DCV CASTING DESIGN CHANGE

DCV PRODUCT BULLETIN

CHANGE IN CURRENT DESIGN ON:

- 1-SPOOL VALVE
- 2-SPOOL VALVE
- 3-SPOOL VALVE

DESIGN CHANGE

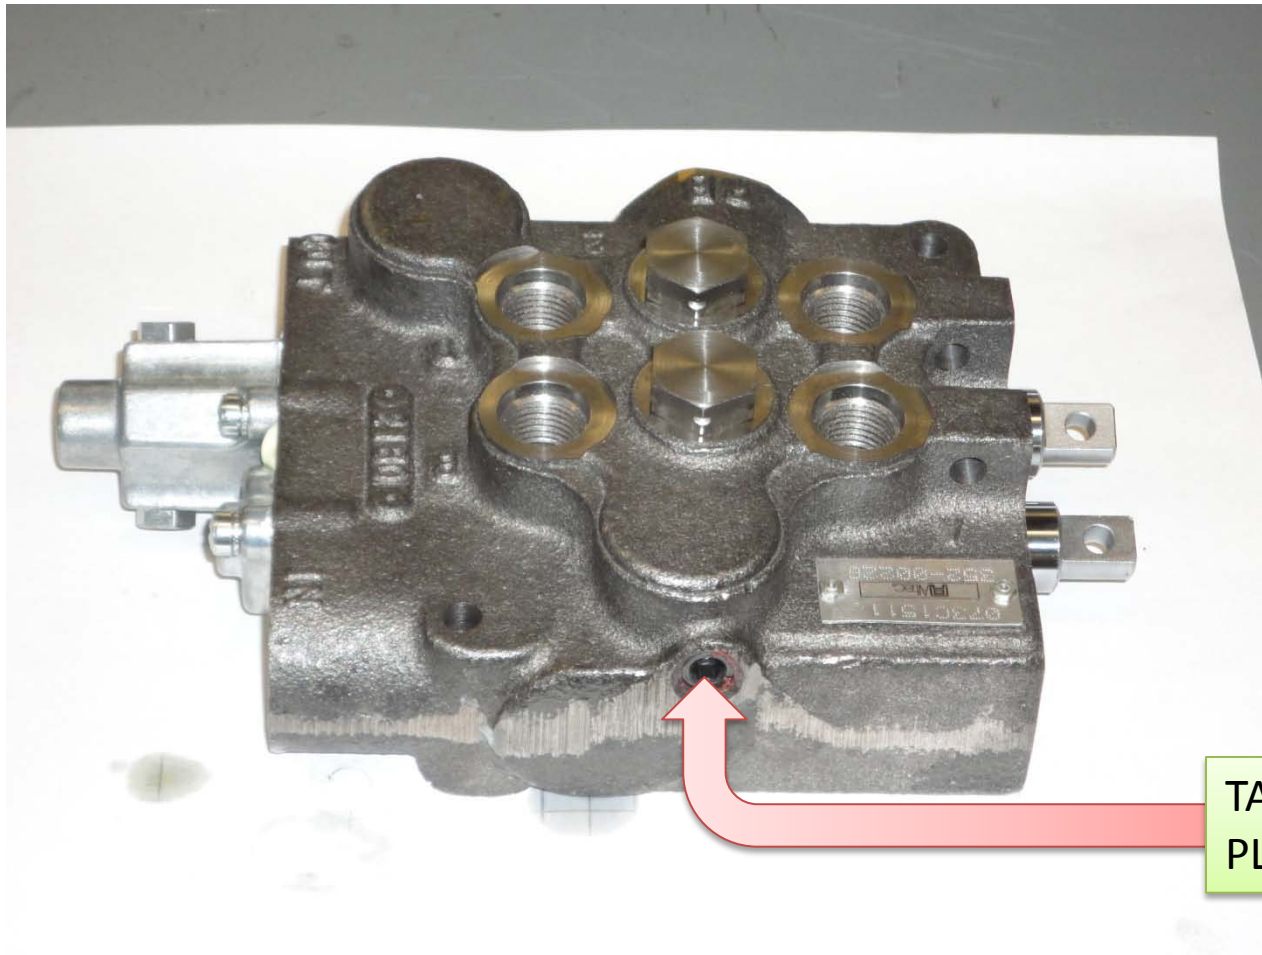
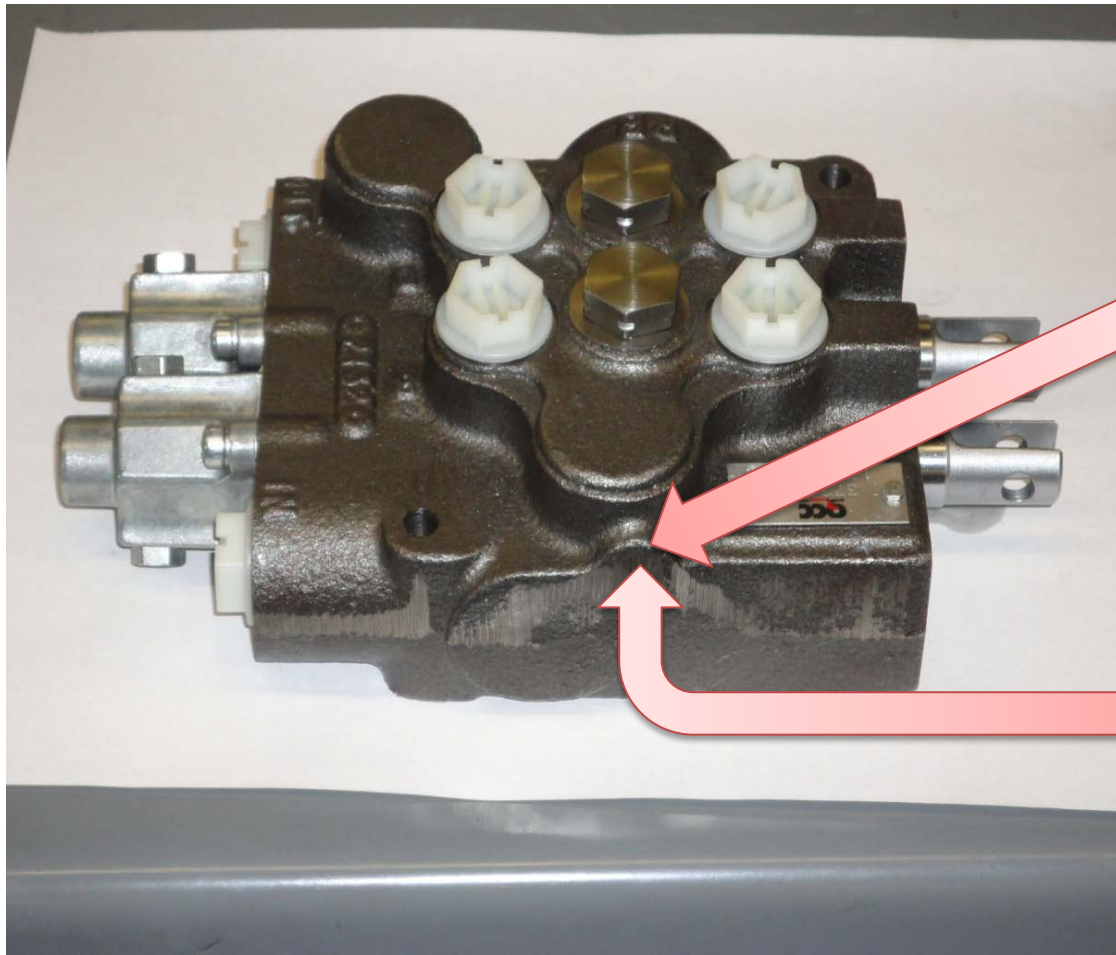
CURRENT DESIGN

TAPPED HOLE WITH
PLUG INSTALLED

FUTURE DESIGN

REMOVE THE RADIUS
FROM THE CASTING
SURFACE

REMOVED THE TAPPED
HOLE AND PLUG

- NO CHANGE IN VALVE FUNCTIONALITY
- THIS FEATURE CHANGE WILL IMPROVE:
 - ❖ CASTING SCRAP RATE
 - ❖ MANUFACTURABILITY
